DESIGN REVIEW COMMITTEE

August 21, 2024 6:00 PM

**DEPARTMENT OF PLANNING AND ZONING
PLANNER'S REPORT**

RE: Design Review – 3293 Dogwood Drive

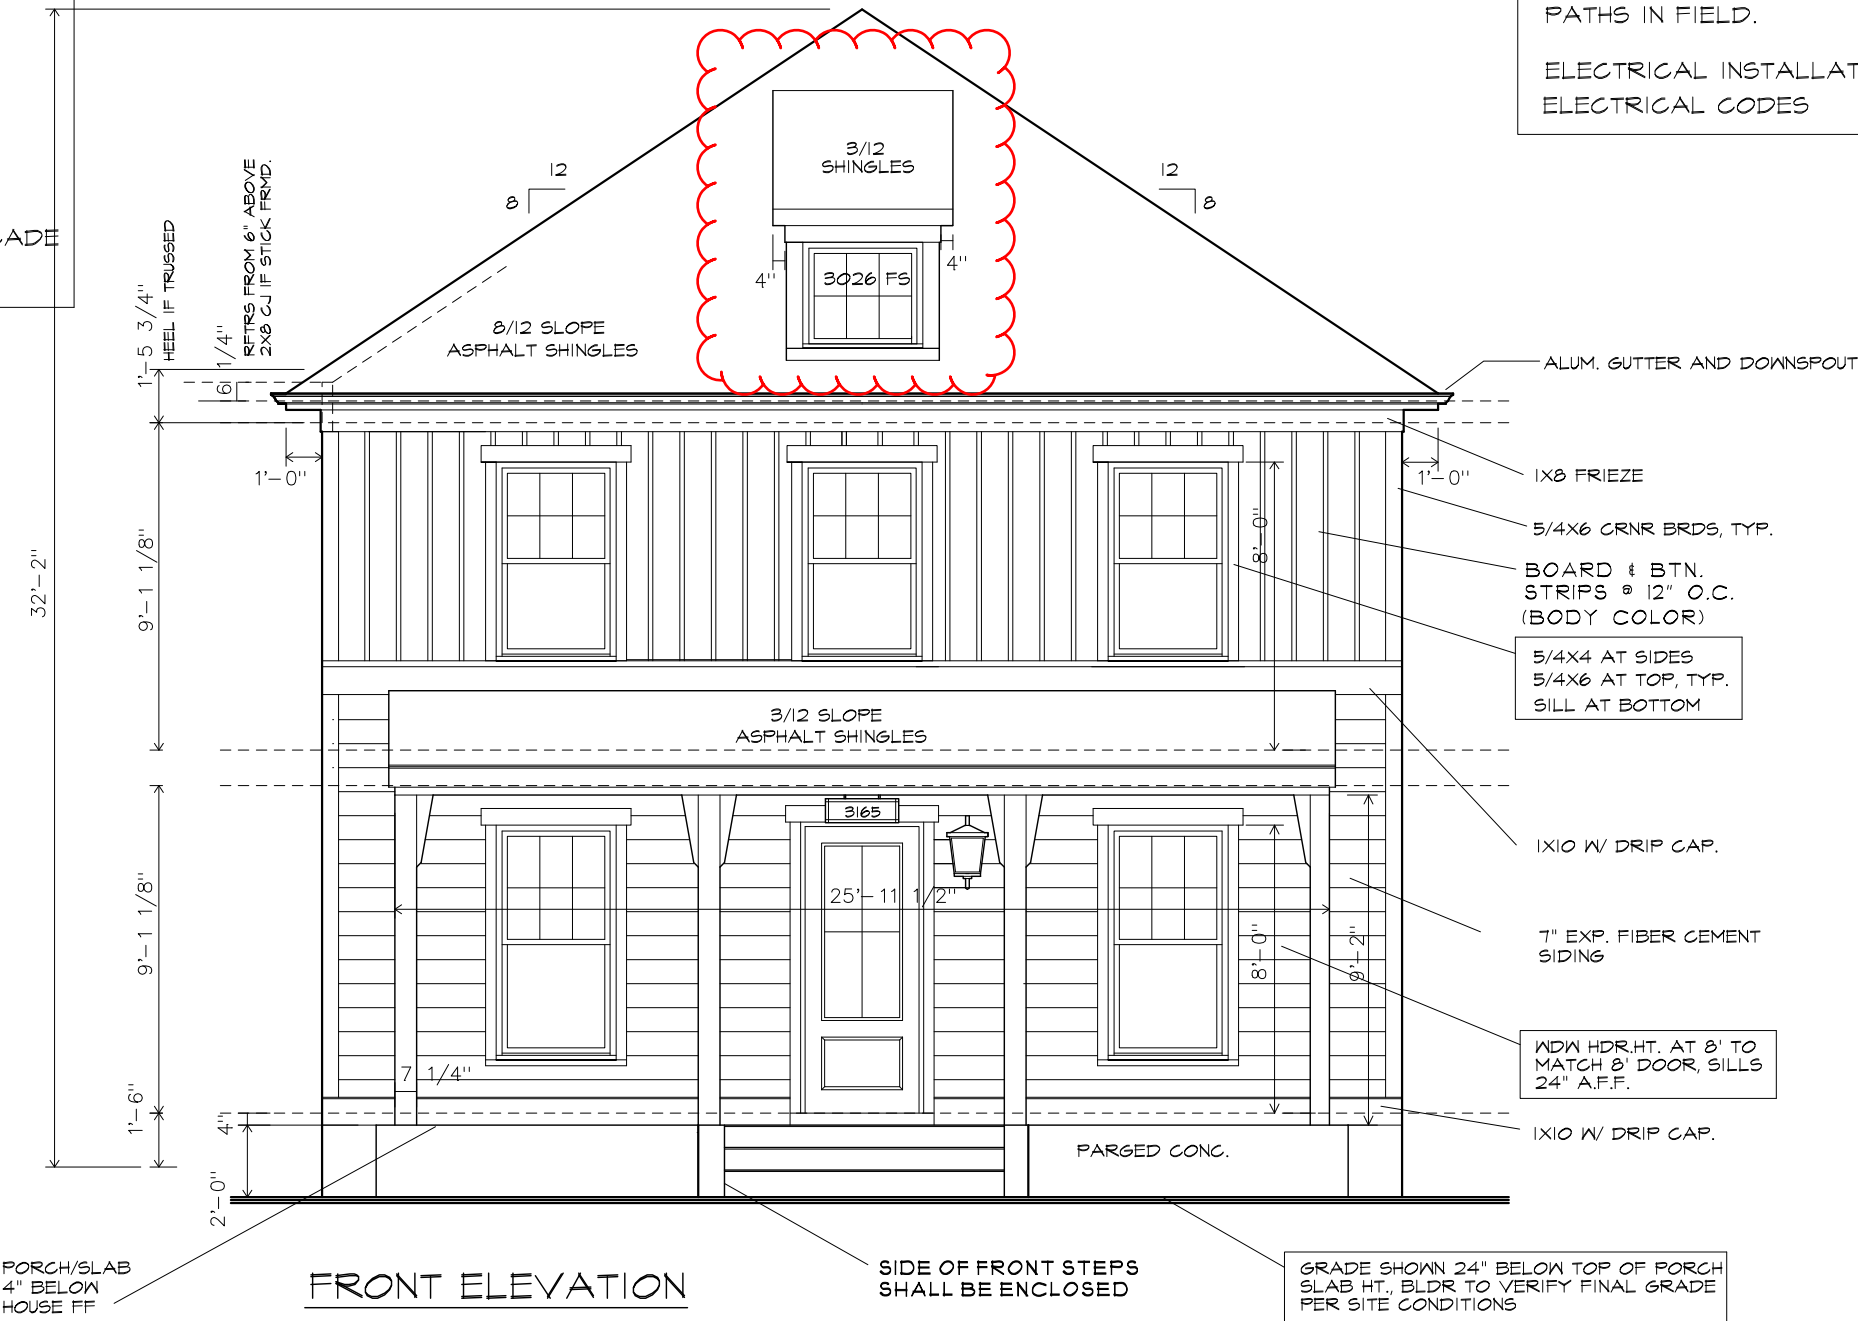
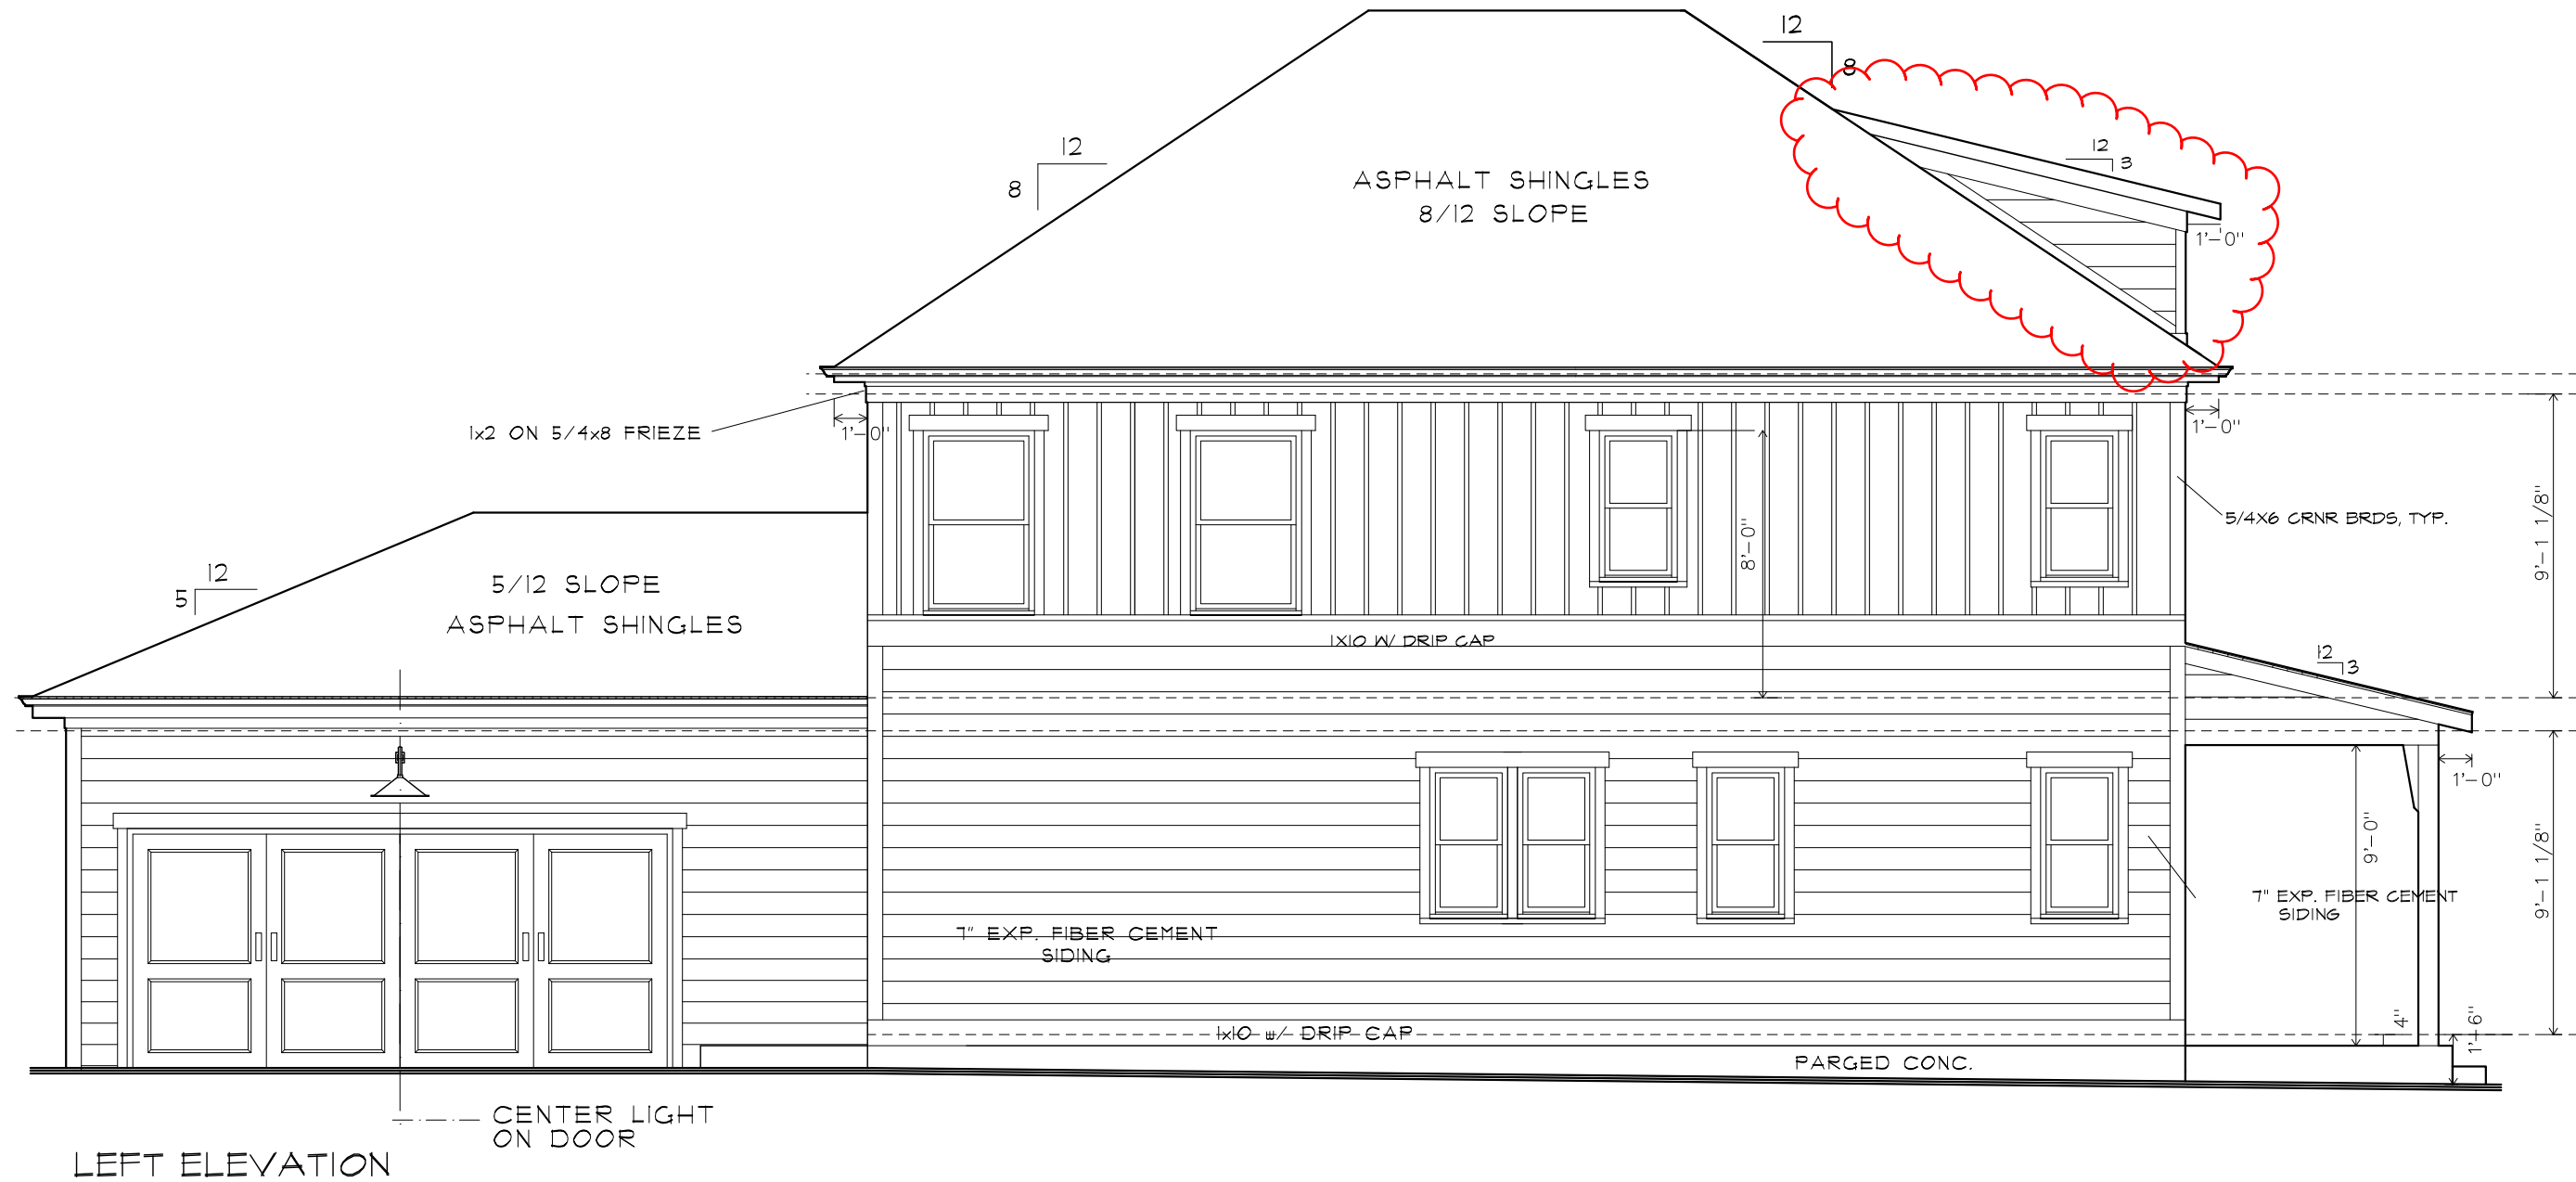
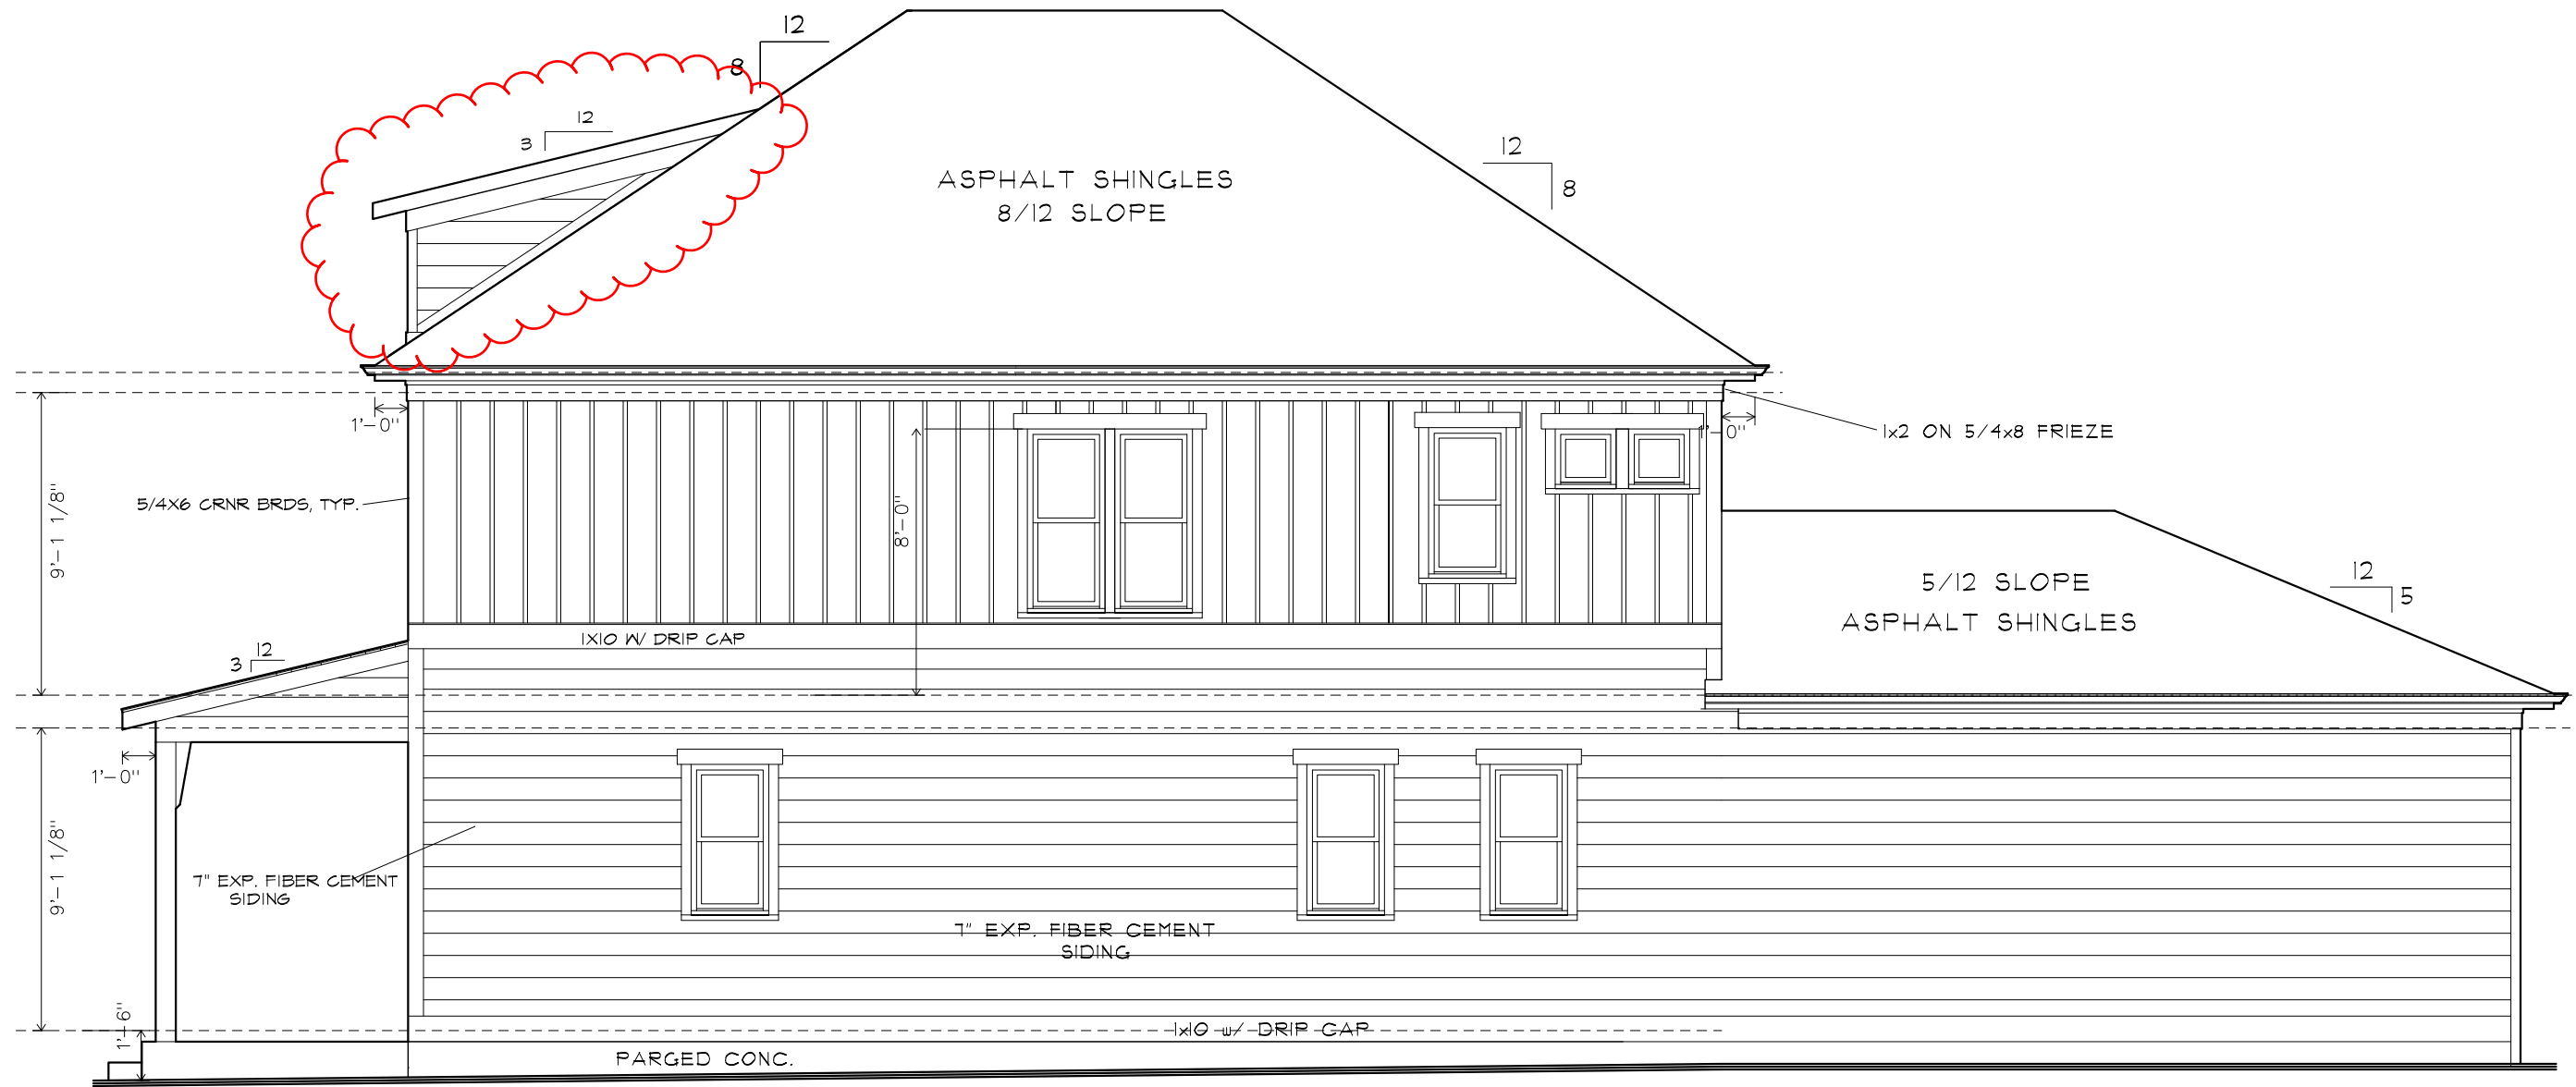
We would like to request changing the front elevation on the home at 3085 Jackson St. to include the dormer that was intended to be on the home at 3163 Old Jonesboro Rd. Please see attached drawings with revisions highlighted. Both floor plans are the same, and they used the plans from lot 3 for lot 2. Shingles were installed prior to catching error. Thank you for your consideration.
